Addendum	01
Date:	July 28 th , 2026
Project:	KGCC – Clubhouse 2026-01
Address:	777 Clonsilla Av. Peterborough, On

1 INTENT

4. ARCHITECTURAL DRAWINGS

FILE No. 586
DWG. No. **E1S**

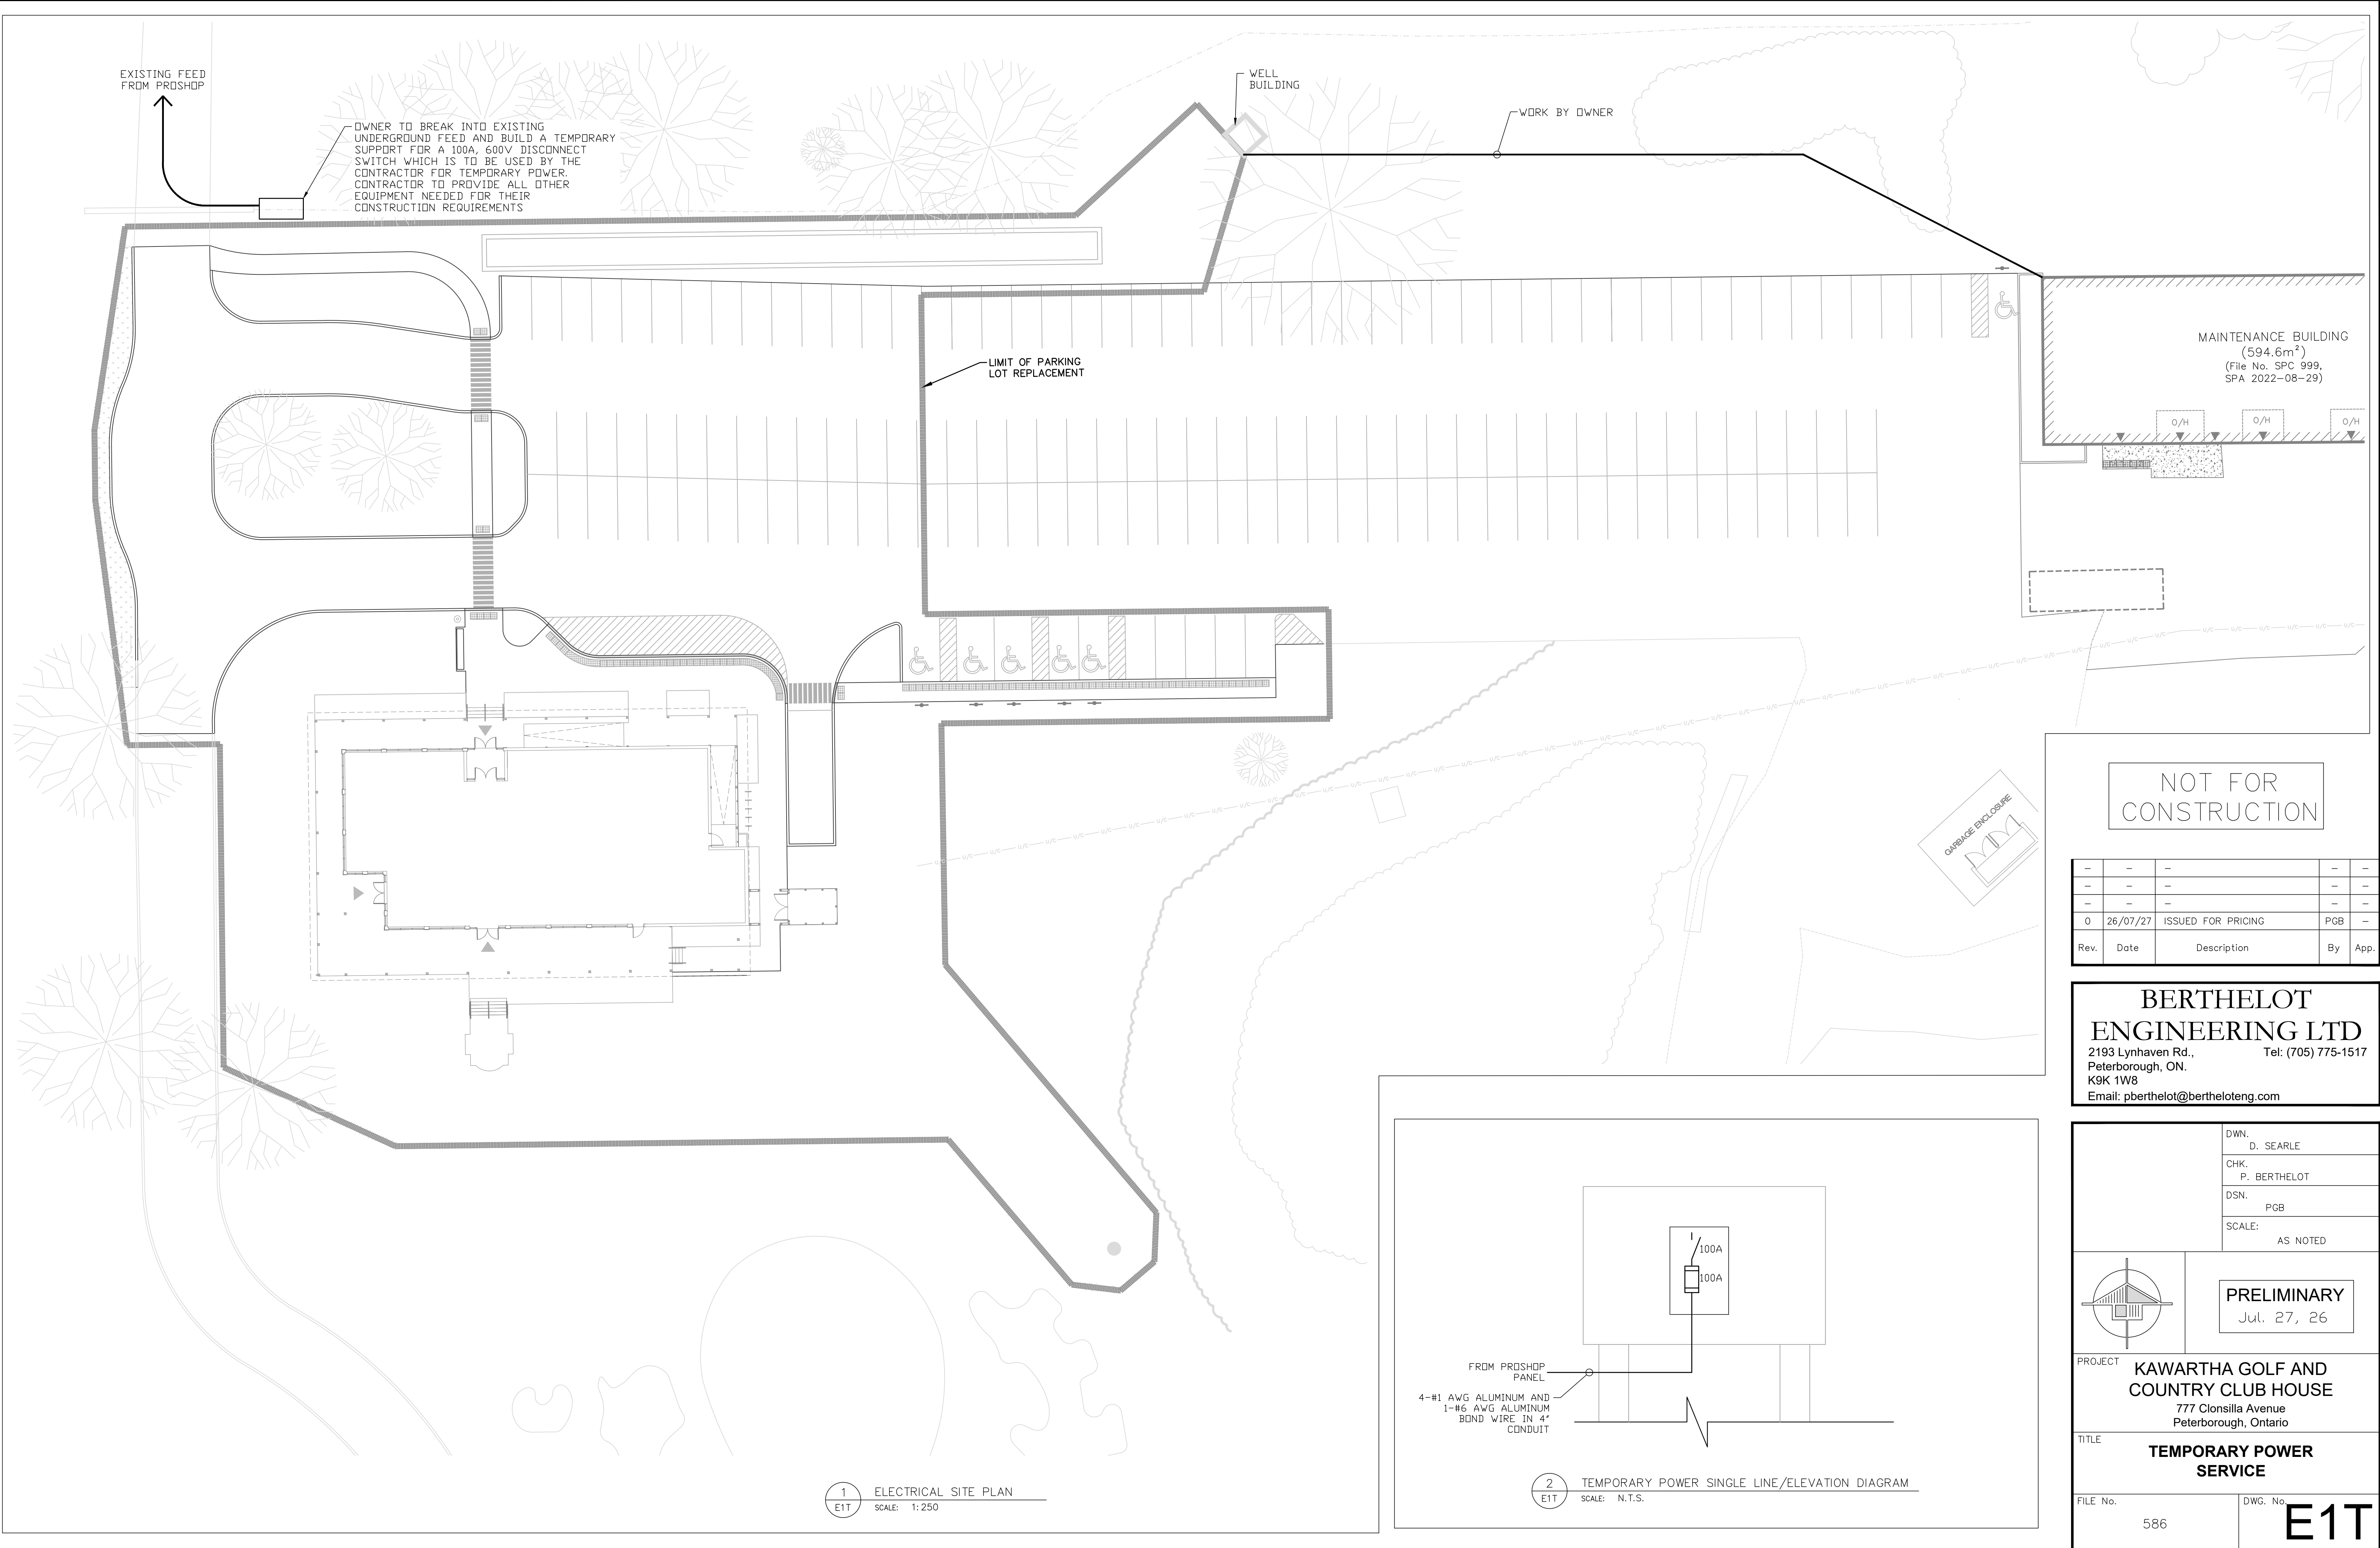
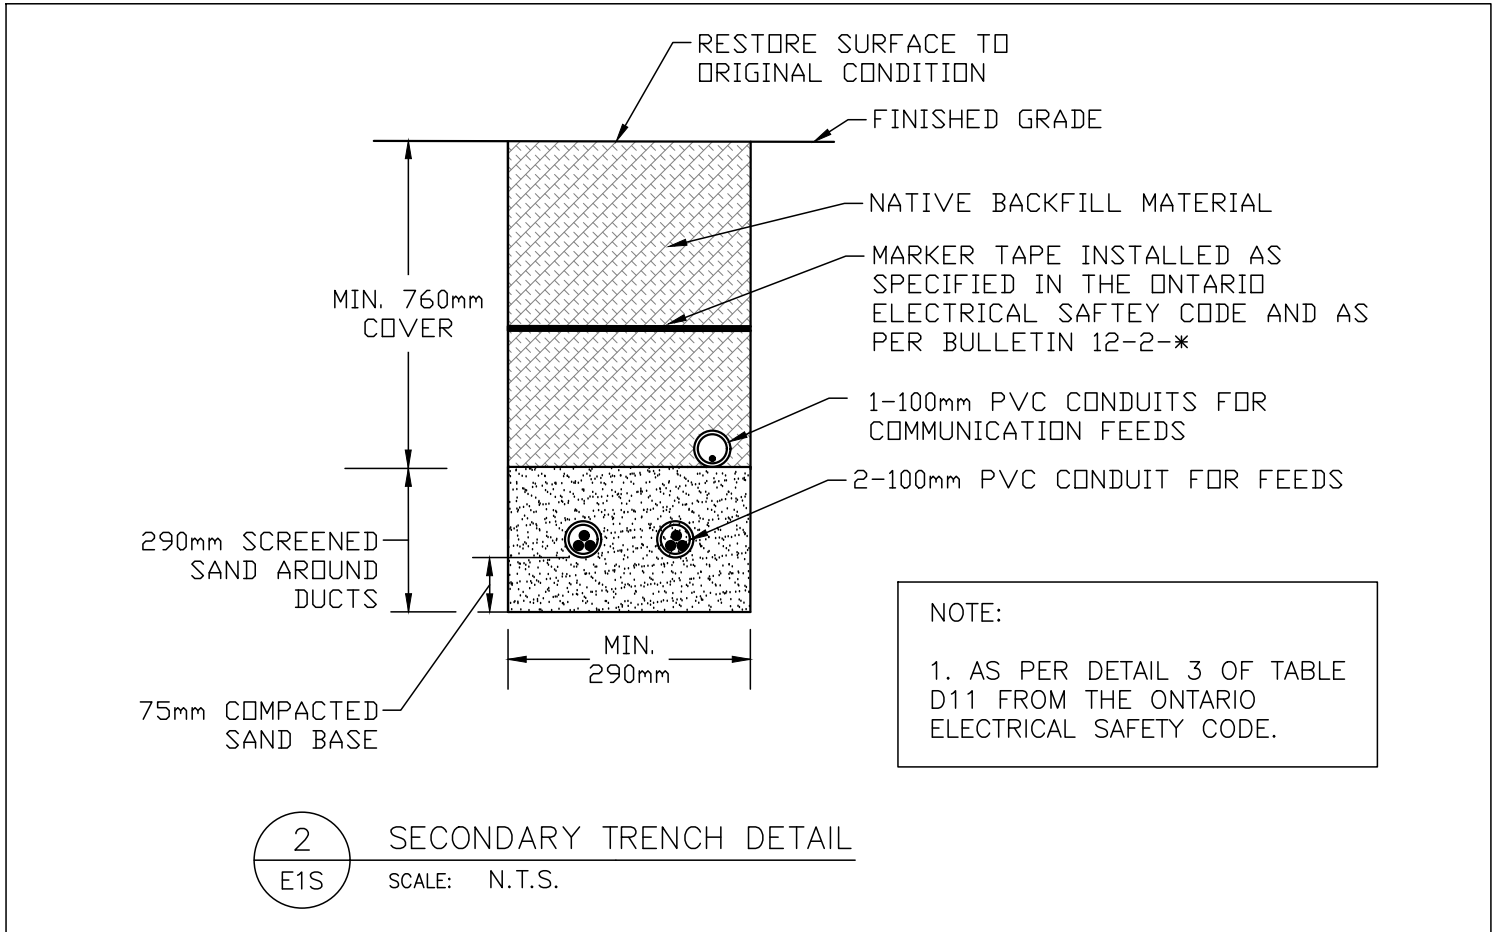
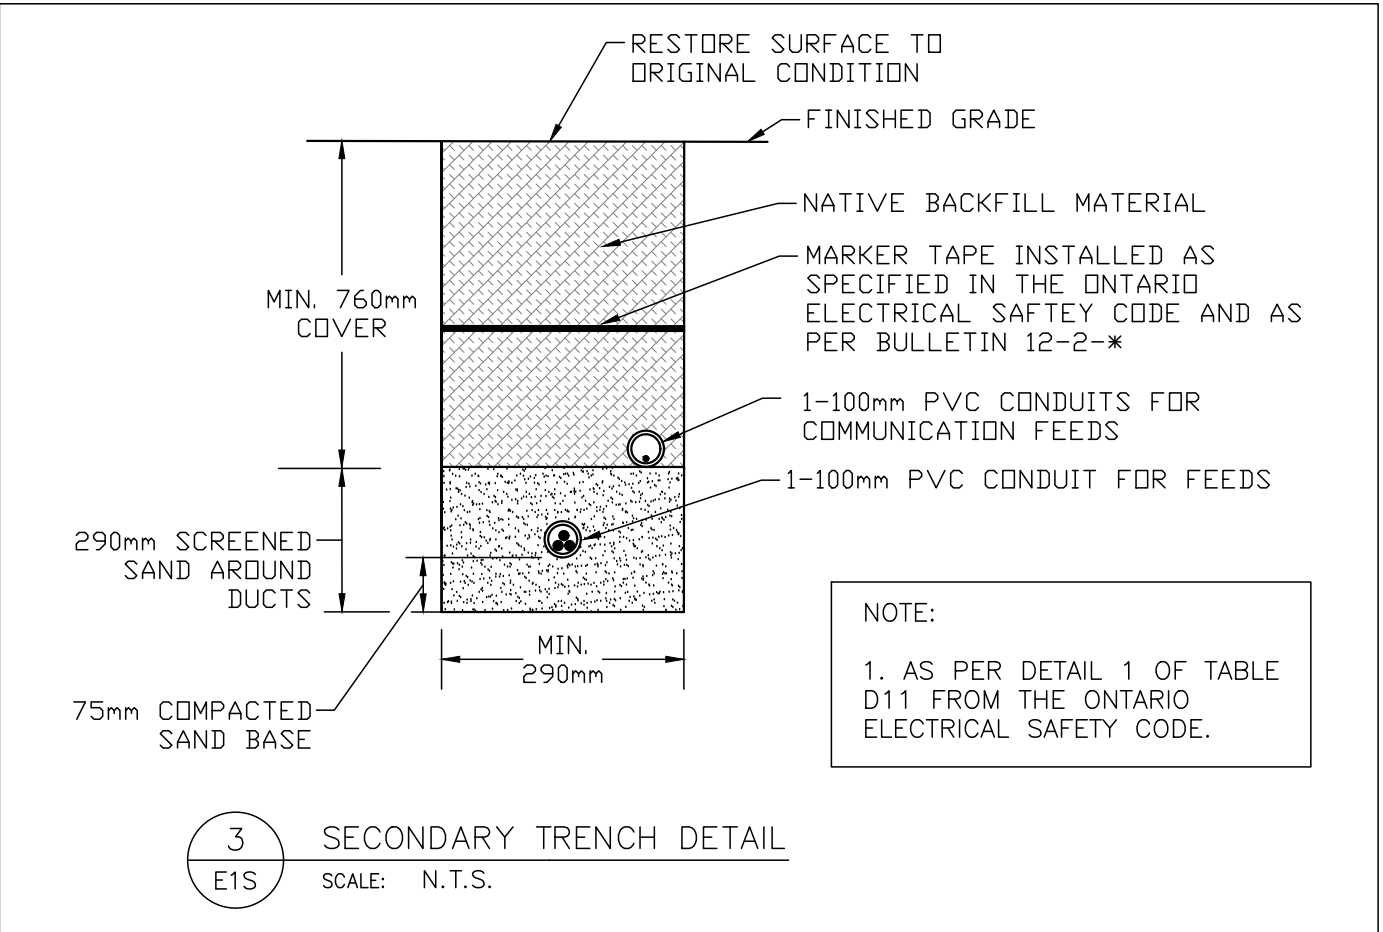
7.1. ADD Site Lighting drawings to contract:

E1S – ELECTRICAL SITE PLAN

E2S - LIGHTING DETAILS
